Reply to review #1

Figure 3. Map showing slope angles in the Ludian seismic area

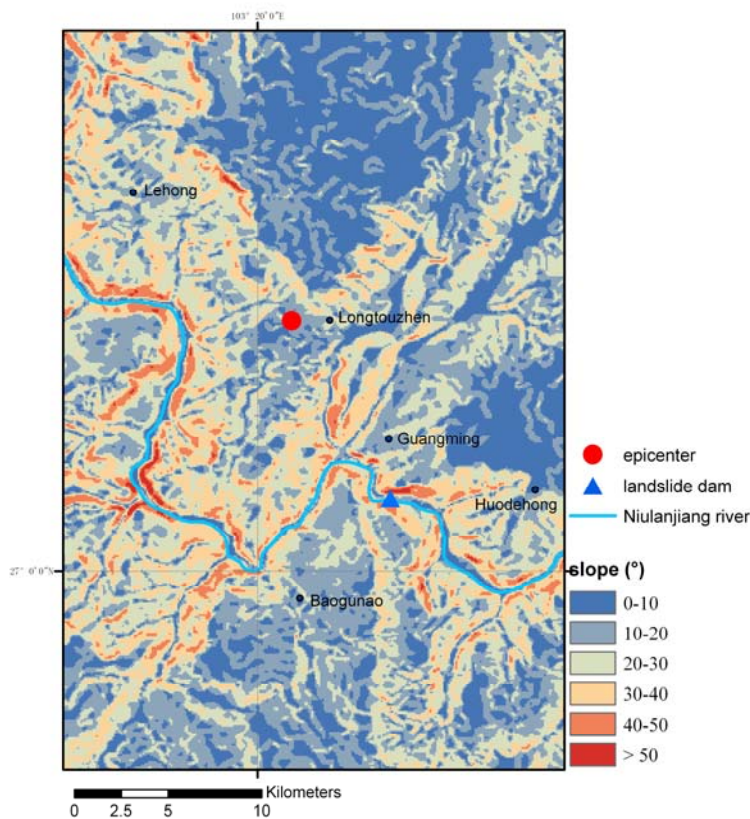
2. Figure 3 The name of the river may be "Niulanjiang River".

Answer: The name of the river is corrected as "Niulanjiang River" in Figure 3.
